# UNITED STATES PATENT AND TRADEMARK OFFICE

| APPLICATION NO.  | FILING DATE | FIRST NAMED INVENTOR | ATTORNEY DOCKET NO. | CONFIRMATION NO. |
|--|-------------|----------------------|---------------------|------------------|
| 10/821,737   | 04/09/2004  | Jochen Schweinbenz   | 10191/3610          | 1521             |

### Office Action Summary

**Fig 1**

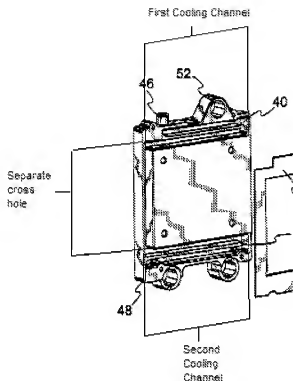
With respect to claim 9, Clamp et al. further teaches that the cooling device includes a plurality of one-piece cooling tubes integrally formed in the bottom section (See Present Office Action Fig 1 below where the first cooling channel, and the second cooling channel, form a plurality of one-piece cooling ducts).

With respect to claim 10, Clamp et al. further illustrates that the one-piece cooling tubes are connected by at least one separate cross hole (Running along the left side of the bottom as illustrated in Fig 2 and present office action Fig 1 below).
